# UNITED STATES PATENT AND TRADEMARK OFFICE

APPLICATION NO.	FILING DATE	FIRST NAMED INVENTOR	ATTORNEY DOCKET NO.	CONFIRMATION NO.
10/736,618	12/17/2003	Yoshihiro Ohkura	X2007.0147	4069
32172	7590	06/01/2006	EXAMINER	
DICKSTEIN SHAPIRO MORIN & OSHINSKY LLP 1177 AVENUE OF THE AMERICAS (6TH AVENUE) 41 ST FL. NEW YORK, NY 10036-2714			NGUYEN, DILINH P	
			ART UNIT	PAPER NUMBER
			2814

**Office Action Summary**

## DETAILED ACTION

Fig.1

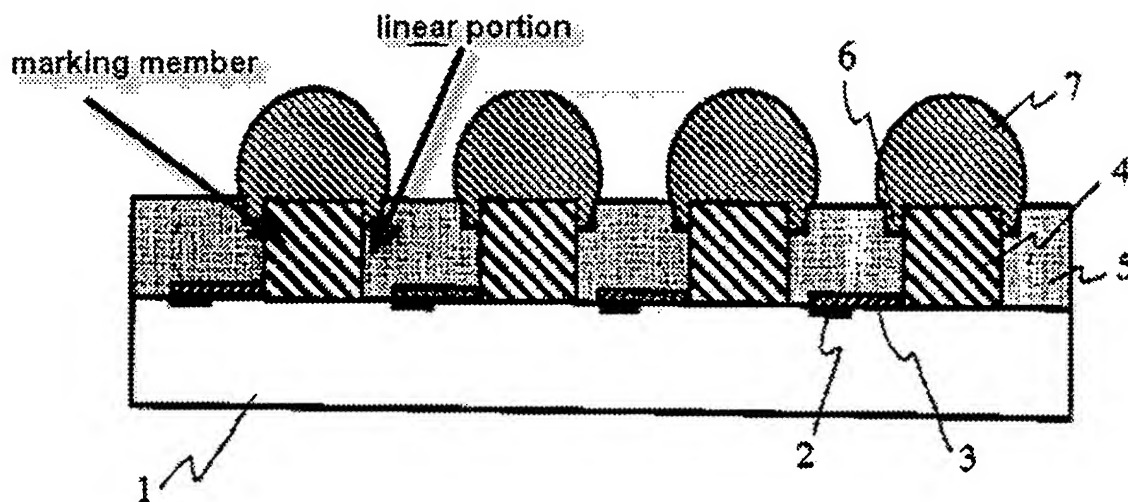
2. Claim 1 is rejected under 35 U.S.C. 102(e) as being anticipated by Ohuchi et al. (U.S. Pat.6495916) (previously applied).

Ohuchi et al. disclose a surface mount chip package incorporating a semiconductor chip having an integrated circuit, comprising:

a package housing 5 made of a resin that covers the semiconductor chip 1 while avoiding a plurality of conductors 4 extending from the semiconductor chip 1;

a plurality of external electrodes 7 that are arranged in the package housing 5 in correspondence with a main surface of the semiconductor chip having the integrated circuit and are connected with the plurality of conductors extending from the semiconductor chip; the external electrodes 7 each having a circular shape when viewed in a vertical direction when the semiconductor chip is held horizontally; and

at least one marking member that is arranged in the package housing so as to realize a directivity when viewed in the vertical direction, wherein an outline shape of the marking member includes at least one linear portion as view from the vertical direction (fig. 1, column 2, lines 56 et seq.).

- Regarding claim 3, Ohuchi et al. disclose that the marking member corresponds to a copper post (fig. 1, column 3, line 1) but do not explicitly disclose the marking member is arranged independently of the plurality of conductors. However, AAPA discloses that the marking member 520 is arranged independently of the plurality of conductors (fig. 6). Therefore, it would have been obvious to one having ordinary skill in the art to modify the device of Ohuchi et al. by having the marking member is arranged independently of the plurality of conductors, as taught by AAPA (fig. 6), in order to provide an index solder ball for use for the chip direction (page 2, lines 21-22).

- Regarding claim 4, Ohuchi et al. disclose that the copper post serving as the marking member has a square shape (fig. 1).
- Regarding claim 5, Ohuchi et al. disclose that the copper post is covered with a solder layer 7 (fig. 1, column 3, line 35).

- Regarding claim 6, Ohuchi et al. disclose that the marking member has a square shape (fig. 1).
- Regarding claims 7-9, Ohuchi et al. disclose that the marking member corresponds to a copper post (column 3, line 1) and it would have been obvious to increase in size compared with each of the plurality of conductors 4 (fig. 1).
